# 40 STATION APPROACH

SECTION 73 - PLANNING DRAWINGS AMENDMENTS

CONSENTED PLANNING DRAWINGS PLANNING REF. 27345/APP/2021/1291	SECTION 73 PROPOSED DRAWINGS
PROPOSED GROUND FLOOR PLAN	001_2000 REV.03	21002-STY-00-DR-A-P01-100-A
PROPOSED FIRST FLOOR PLAN	001_2001 RE.02	21002-STY-01-DR-A-P01-101-A
PROPOSED SECOND FLOOR PLAN	001_2002 REV.02	21002-STY-02-DR-A-P01-102-A
PROPOSED ROOF PLAN	001_2003 REV. 02	21002-STY-03-DR-A-P01-103-A
PROPOSED SITE PLAN	001_2005 REV. 03	21002-STY-00-DR-A-P00-001-A
PROPOSED SITE CONTEXT PLAN	001_2006 REV. 02	21002-STY-00-DR-A-P00-002-A
PROPOSED NORTH ELEVATION	001_2020 REV. 03	21002-STY-ZZ-DR-A-P03-301-A
PROPOSED WEST ELEVATION	001_2021 REV. 04	21002-STY-ZZ-DR-A-P03-302-A
PROPOSED SOUTH ELEVATION	001_2022 REV. 03	21002-STY-ZZ-DR-A-P03-303-A
PROPOSED EAST ELEVATION	001_2023 REV. 03	21002-STY-ZZ-DR-A-P03-304-A
PROPOSED STREET SCENES	001_2030 REV. 03	21002-STY-ZZ-DR-A-P03-300-A
PROPOSED STREET SECTIONS	001_2031 REV. 03	21002-STY-ZZ-DR-A-P02-200-A

## 1.3.2 OVERLAY WITH APPROVED PLANNING DRAWINGS

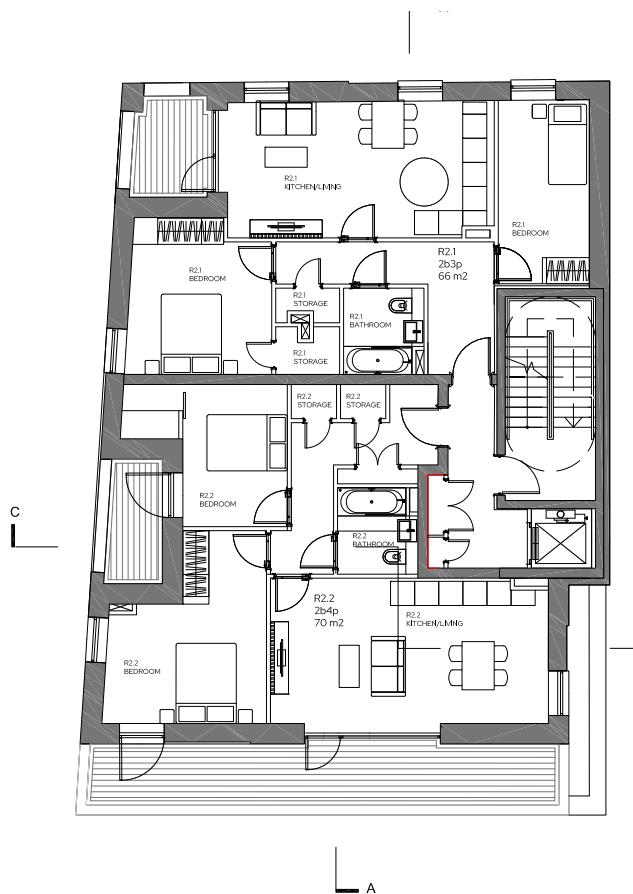
External wall thickness increased from 300mm to 508 mm to meet NBHC and Part B standards.

Staircase increased in width and length to comply with Part K.

Balcony size had to increase to meet minimum space standards.

Position of bathrooms on all floors had to shift in order to be able to stack risers.

Internal built-in storage has been included as per the minimum space standard requirements.

Terrace is extended as the proposed sedum roof cannot be maintained efficiently.

Risers in the communal area and the flats have previously not been included. These have been added and stacked.

Massing of the building has increased in order to comply with minimum space standards for each flat.

Terrace extended to provide bedroom with access to external amenity space.

## 1.4.2 OVERLAY WITH APPROVED PLANNING DRAWINGS

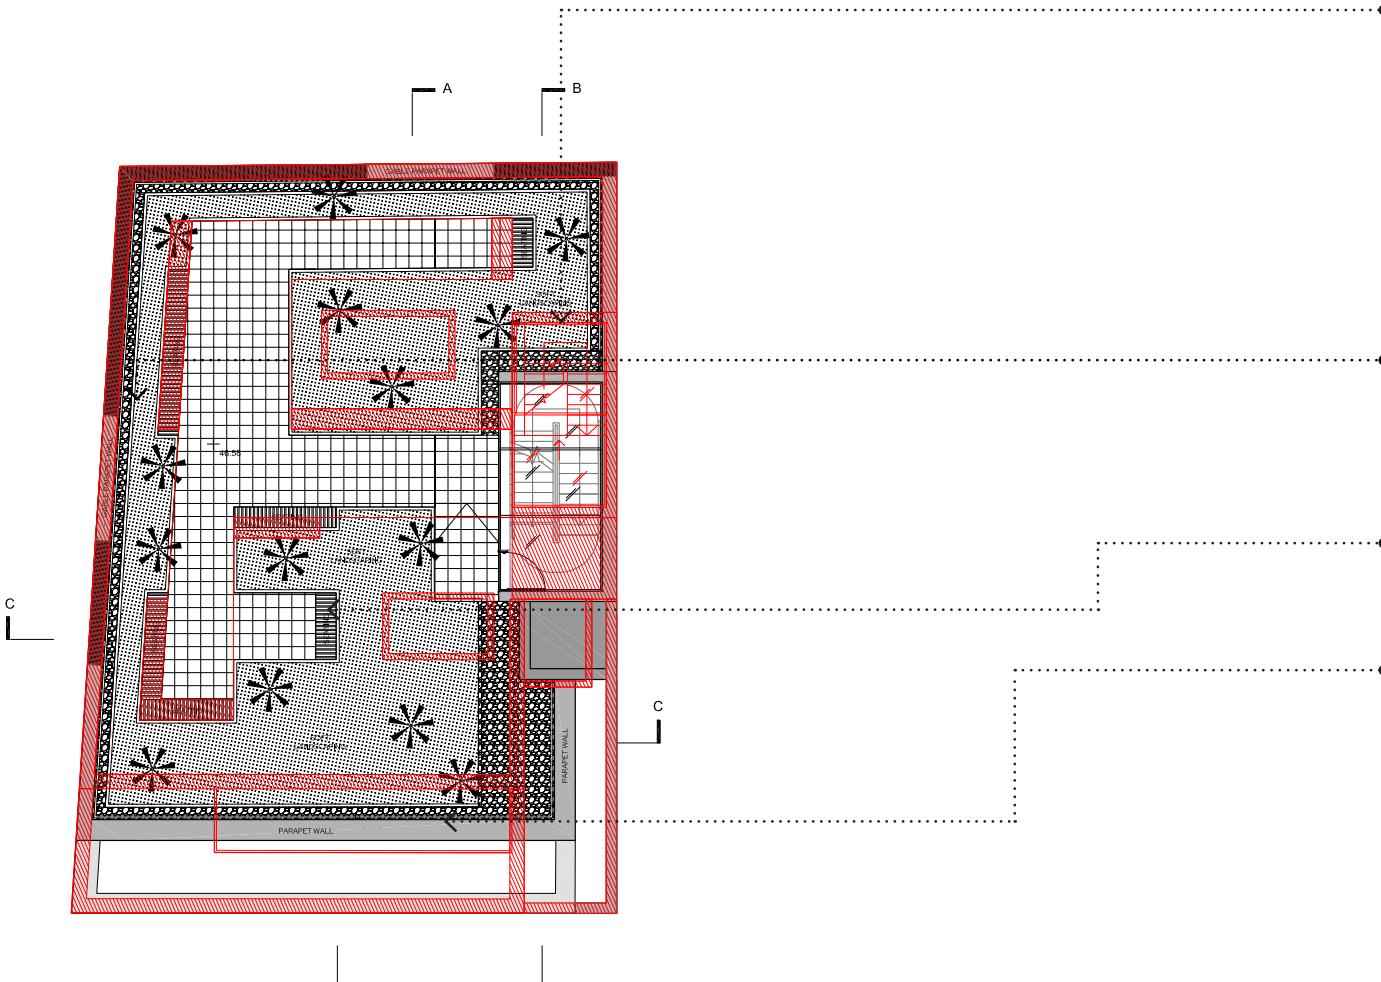
Staircase increased in width and length to comply with Part K.

Due to the footprint of the second floor slightly increasing, the size of the terrace has also increased and therefore delivers more communal amenity space for the residents.

Massing of the building has increased in order to comply with minimum space standards for each flat.

Fire breaks have been integrated around the perimeter of the roofs and any penetrations in line with The GRO Green Roof Code. This does slightly reduce the area of planting.

Lighting added.

Integrated benches rationalised to maximise planting space where it has been reduced by the inclusion of fire breaks.

Balustrade relocated to parapet for a more robust detail and for ease of maintaining both balustrade and the plants.

Zone between parapet and balustrade changed to gravel margin to provide a safer and simpler maintenance strategy.

Approved Planning Drawing  
001\_2040 Rev. 01\_Proposed Section A-A

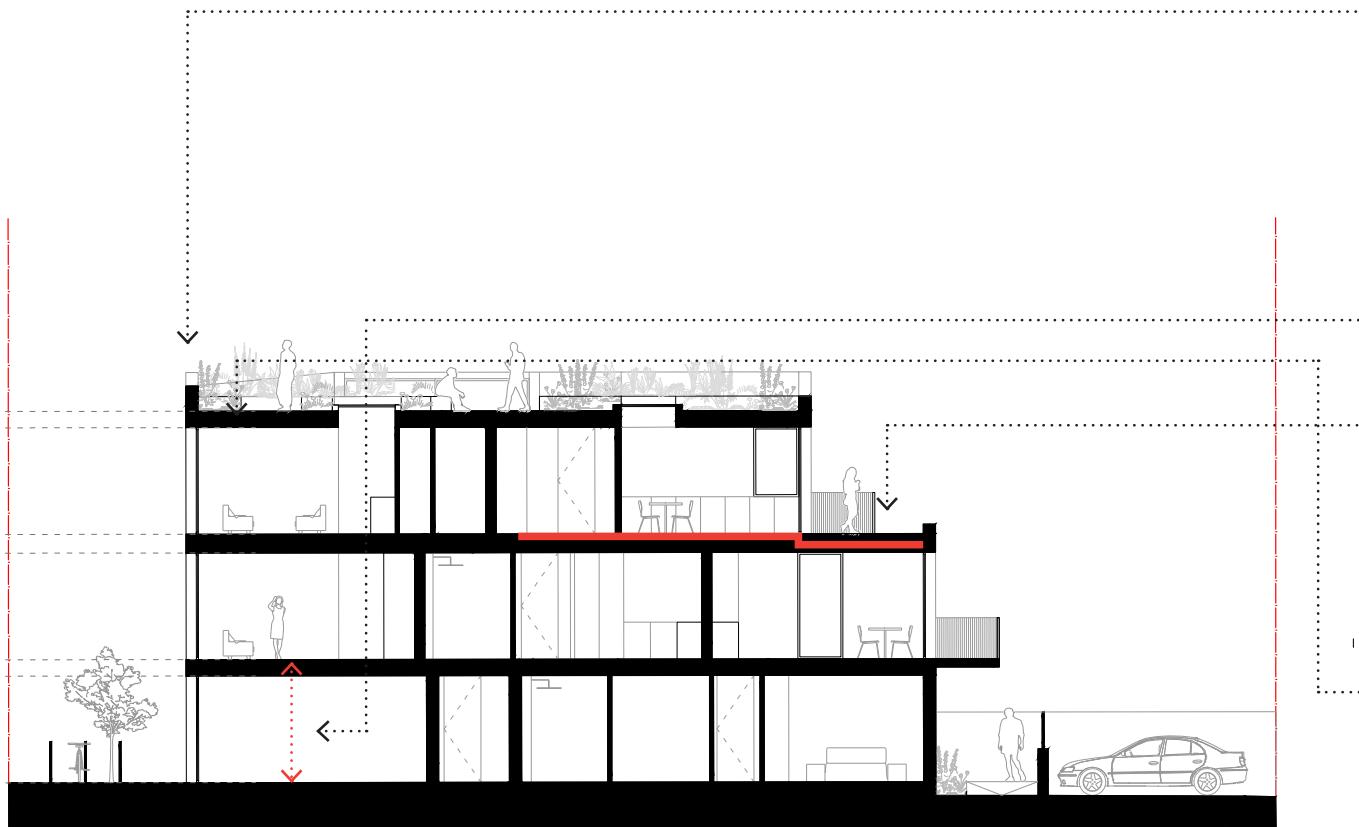
- As per the Hackett report non-combustible materials should be used to all cladding materials. This infers using mineral fibre insulation regardless of whether this is below or above 18 metres.
- In order to accommodate the recommended type of insulation the width of the external walls has to increase from 300mm to 508mm.

- The approved planning drawings indicate a floor to floor height of 3000mm (GF) and 3050mm (upper floors).
- Inset balconies over heated internal spaces require the slab to step down, not only to provide level access but also to allow for the slab to be wrapped in insulation to avoid coldbridging.
- This leads to a reduced floor to ceiling height.
- To achieve a clear internal height of 2500mm and work within brick dimensions the floor to ceiling height is increased to 3150mm.

- To achieve the level of proposed soft landscaping on the roof a minimum of 500mm build up above FFL is required. To support this load the slab thickness has to increase.
- Furthermore, the planning drawings propose a strip of planting between the parapet and the balustrade. This makes maintenance very complicated and requires the balustrade to be raised by 1100mm above the 500mm of soft landscaping to comply with Part K.
- To avoid this the balustrade can be fixed directly to the inside of the parapet.

Revised Drawings  
21002-STY-ZZ-DR-A-P02-201-A\_PROPOSED SECTION A-A

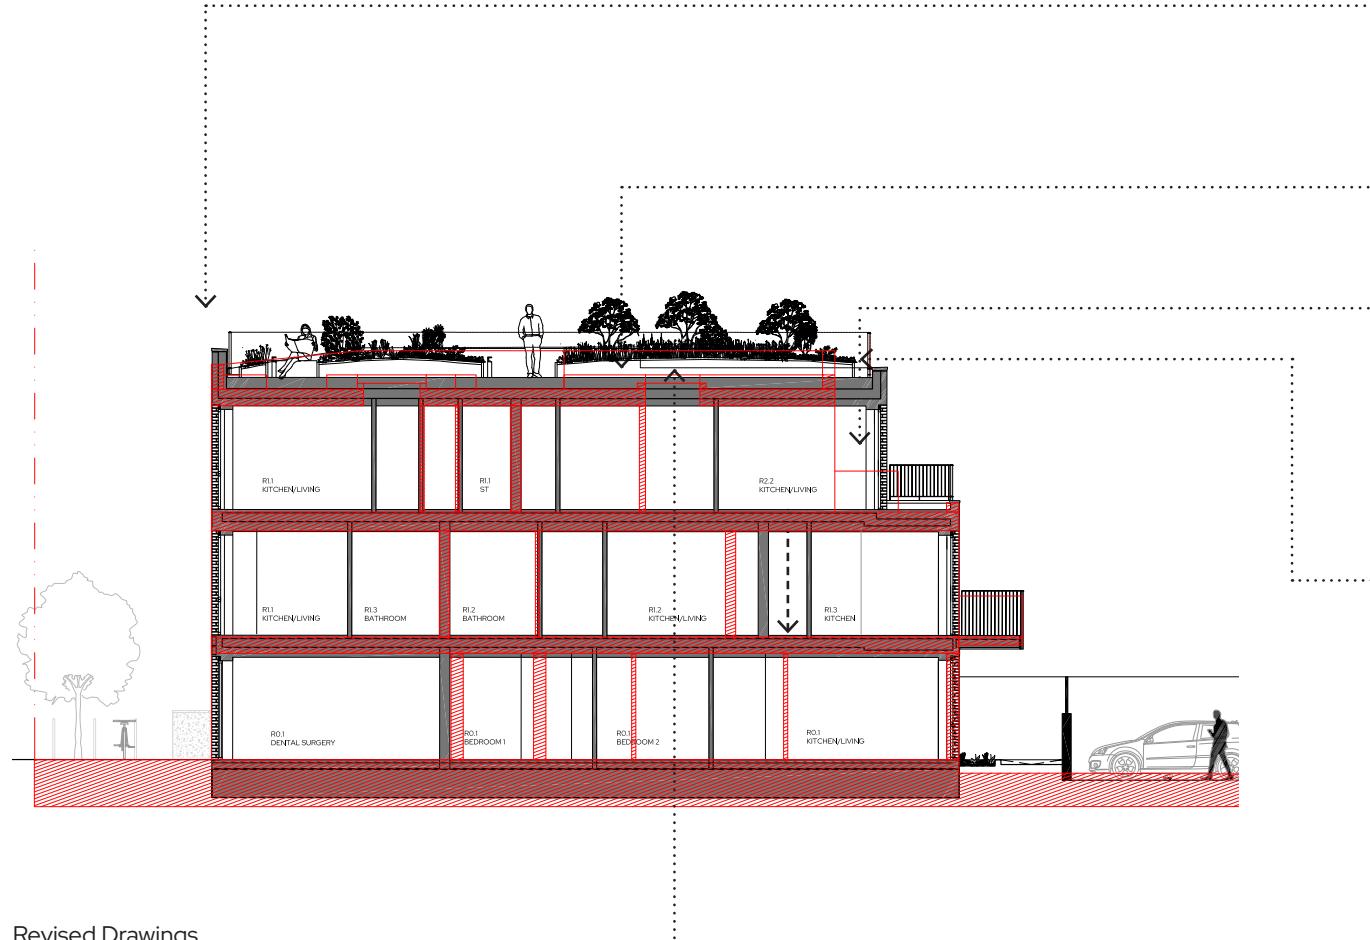
The height of the parapet has remained the same, however the balustrade has had to be raised by 450mm.

To achieve the level of proposed soft landscaping a minimum of 500mm build up above FFL is required. To support this load the slab thickness has to increase.

Footprint of the second floor has increased to comply with minimum space standards for the flats.

Due to the footprint of the second floor slightly increasing, the size of the terrace has also increased and therefore delivers more communal amenity space for the residents.

Zone between parapet and balustrade changed to gravel margin to provide a safer and simpler maintenance strategy.

Fire breaks have been integrated around the perimeter of the roofs and any penetrations in line with The GRO Green Roof Code.

Removal of skylights above the residential flats.
